Layout Review 960

FPD-Link Applications

PoC routing

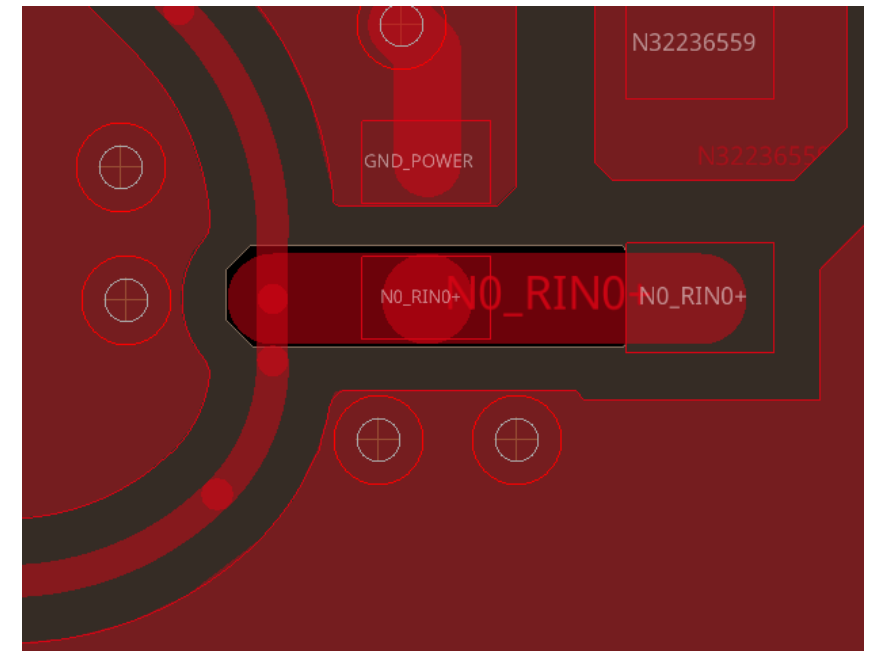
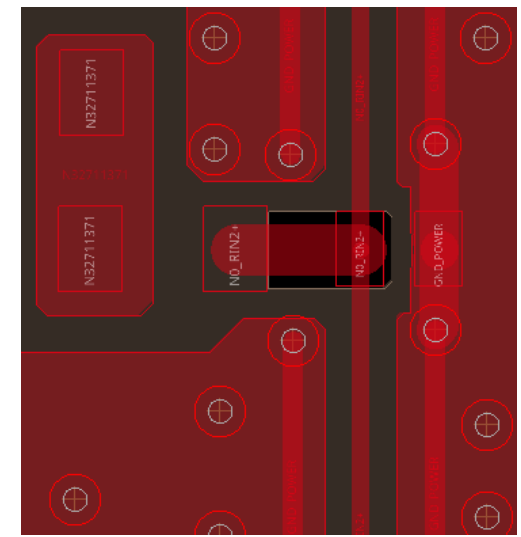
- Anti-pad should present on the first inductor pad touching the DOUT trace
 - Recommend anti pad being placed under both of the component pads, only the component pads
 - Will assist minimizing impedance mismatch through the trace
 - First inductor should be placed orthogonally to the RIN trace, barely touching
- Recommend verifying trace length, PoC insertion loss and return loss channel specifications are met
- Confirm DOUT+ traces can carry PoC current without significant temperature rise

Take care to confirm no significant impedance mismatch with change in trace width through the PoC network routing

RIN AC Coupling Capacitors

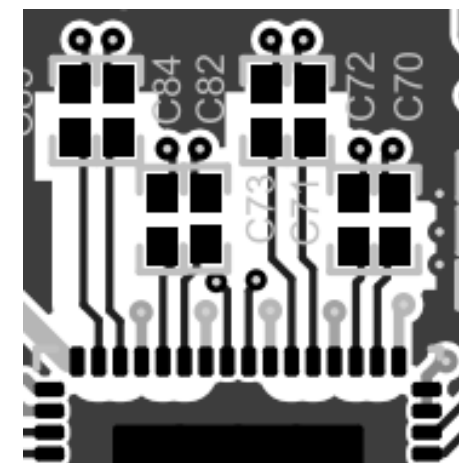
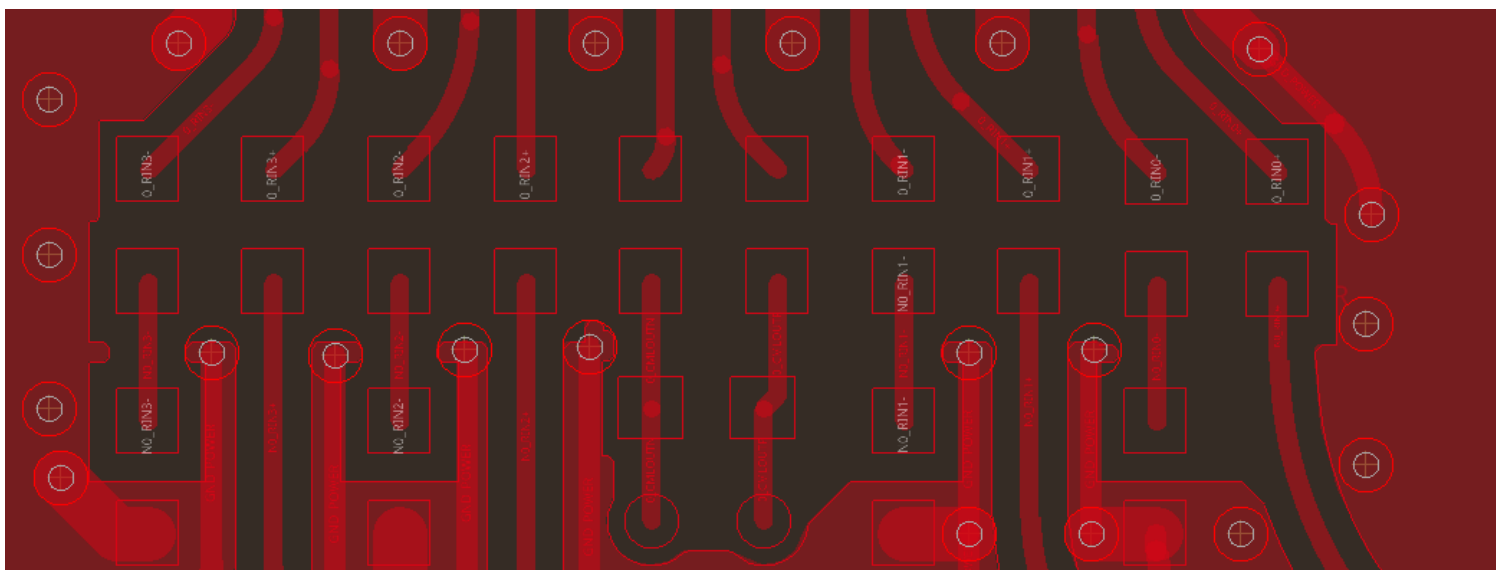
- Recommend placing anti-pads under the AC coupling capacitor pads on the RIN trace
 - size of the anti-pad should match the size of the capacitor pad
- Recommend moving AC coupling capacitors as close as possible to the device
 - Prior to AC coupling capacitor 100 ohm differential impedance between Rin+/- pair
 - Following AC coupling capacitors 50 ohm single ended impedance on the Rin traces
- AC coupling capacitors should be slightly staggered to prevent crosstalk between traces

Irregular via placement

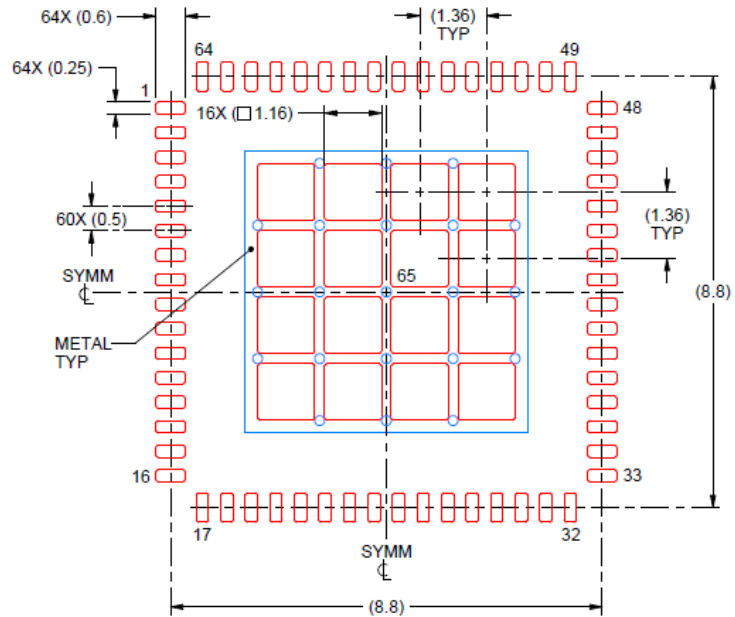
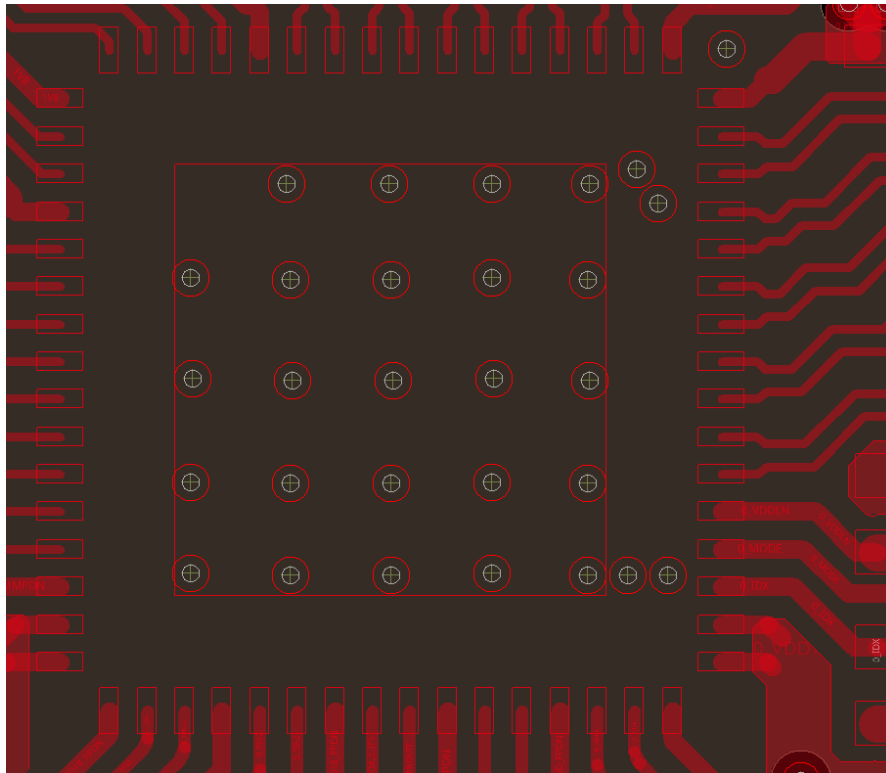
- Recommend following provided landing pattern for thermal requirements

I2C Routing

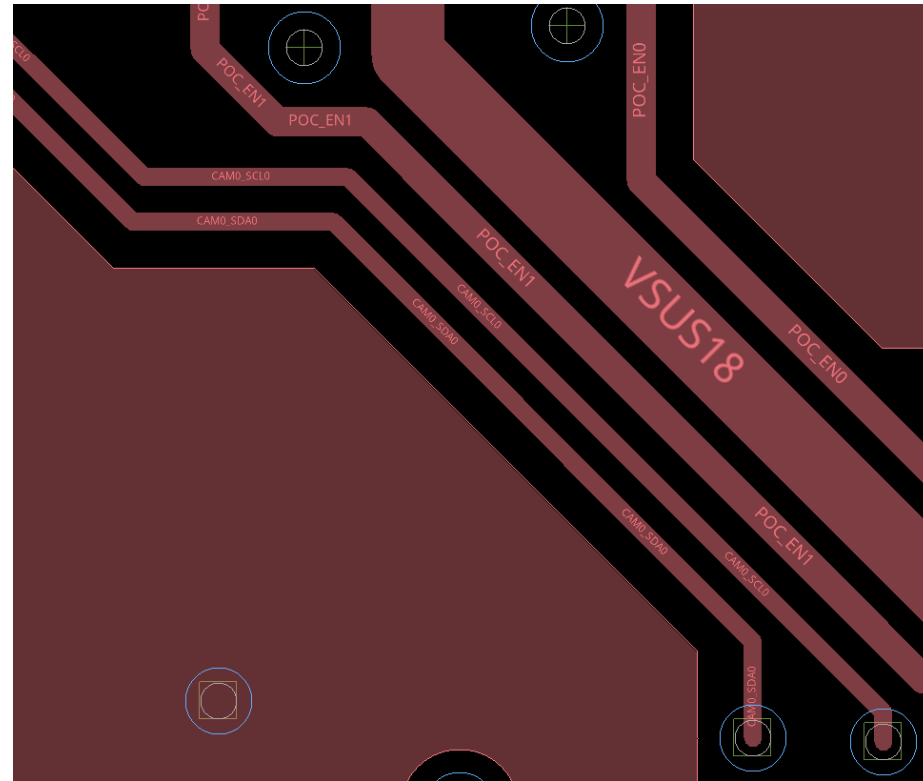
- Consider limiting length of I2C sections routed closely to each other to prevent coupling and noise between traces

FPD-Link routing

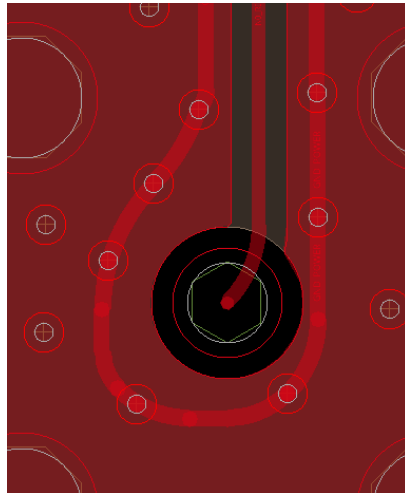
- Consult connector vendor for optimal connector footprint. If the connector is a through-hole component, TI recommends placing the connector on the opposite side of the board to the RIN traces to avoid stubs. This is critical for ensuring good signal integrity.
- Recommend to use simulation to verify the effects of the connector landing pattern on the impedance
